## Guildford Society

### Comments on the Proposed Development North Street Guildford by St Edward Policy A5 Local Plan

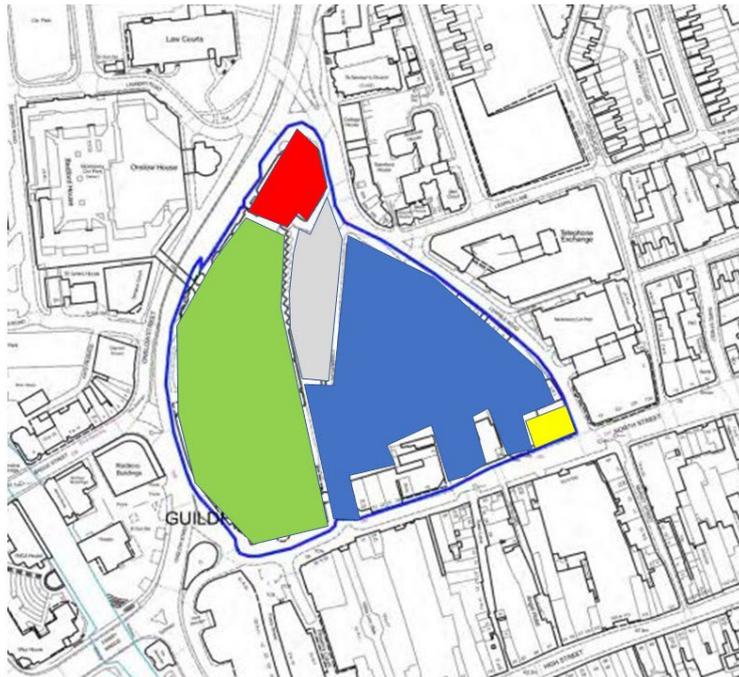
The St Edward North Street Plan is only covering a part of the area in the policy

Our understanding is that the plans are being developed, by the current owners, for No1 Onslow Street and Norwich House, other sites for commercial reasons have not been included in the Site. The Bus Station is utilising the space over the underground No1 Onslow Street parking area, which is difficult to build upon, together with a revision to the Bus Station Parking Bays and access.

- Red - No1 Onslow House Planning Applied for
- Green – Friary Centre
- Grey- Bus Station with No 1 Onslow House parking underneath
- Blue – St Edward North Street
- Yellow – Norwich House Planning Applied For

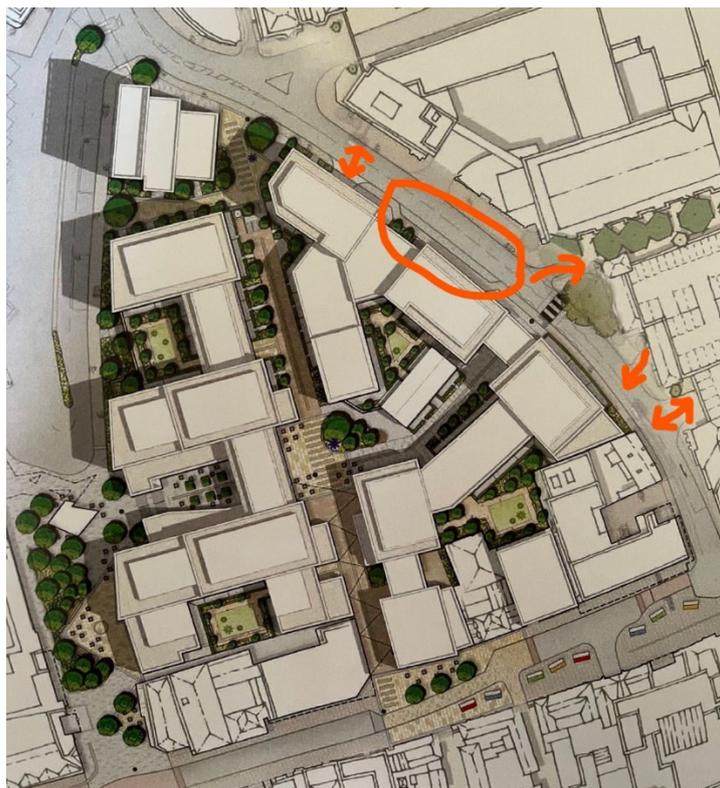
We have remarked on the overall alignment of the development to Leapale Road above. The access arrangements for vehicles to the site appear very limited and focused on Leapale Road

The provision of a single Layby is inadequate – on a scheme of this size there should be allowance for one move every working day (500 dwellings occupied for 5yrs average, gives circa 200 moves (Out/In) per year.

The Society believes, like the St Mary Wharf development, there should an enclosed ground level delivery area (Porte Cochere) for Trucks, Deliveries and Moving Vans

The illustration below highlights the proposed layby, entrance to parking in the development and entrance to the existing Leapale Road Car Park.
